STATE OF UTAH DEPARTMENT OF NATURAL RESOURCES DIVISION OF OIL, GAS AND MINING						FORM 3 AMENDED REPORT <input type="checkbox"/>							
APPLICATION FOR PERMIT TO DRILL						1. WELL NAME and NUMBER 8-18D-46 BTR

DRILLING PLAN

8-18D-46 BTR

ON-SITE PREDRILL EVALUATION

FIGURE #1

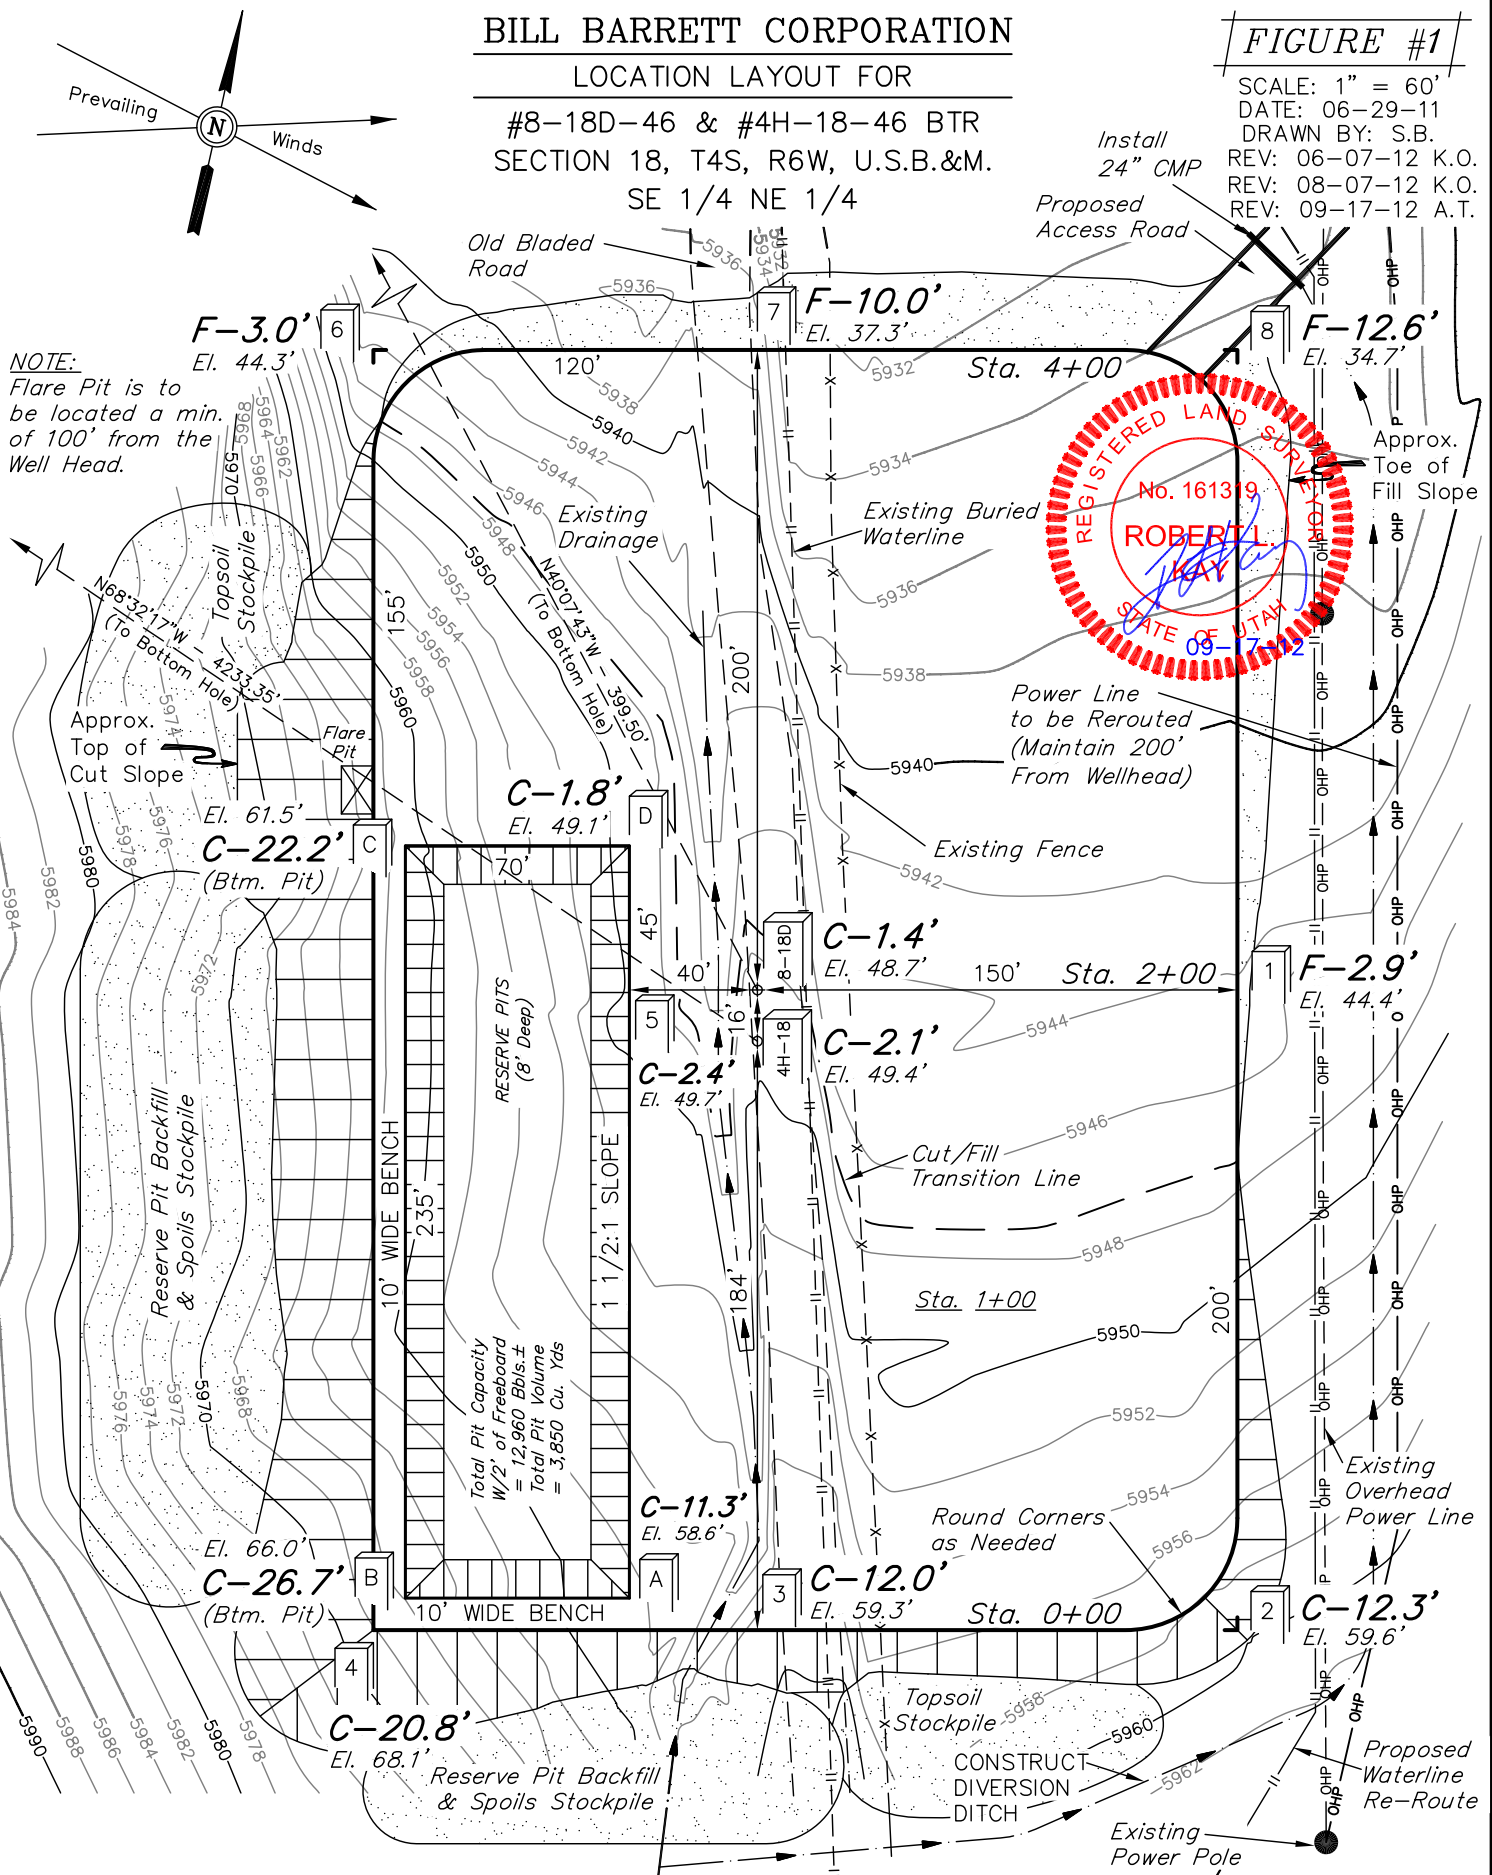
Diversion must be rerouted to the east side of canyon floor and location rip rap

Location should be bermed as there is a small reservoir immediately below the location and the Strawberry River is nearby.

Rip rap should be added to the top of location around drainage diversion

Reserve pit should not be allowed at this site as the canyon drainage runs between the well head and the proposed pit. A closed loop system will be required.
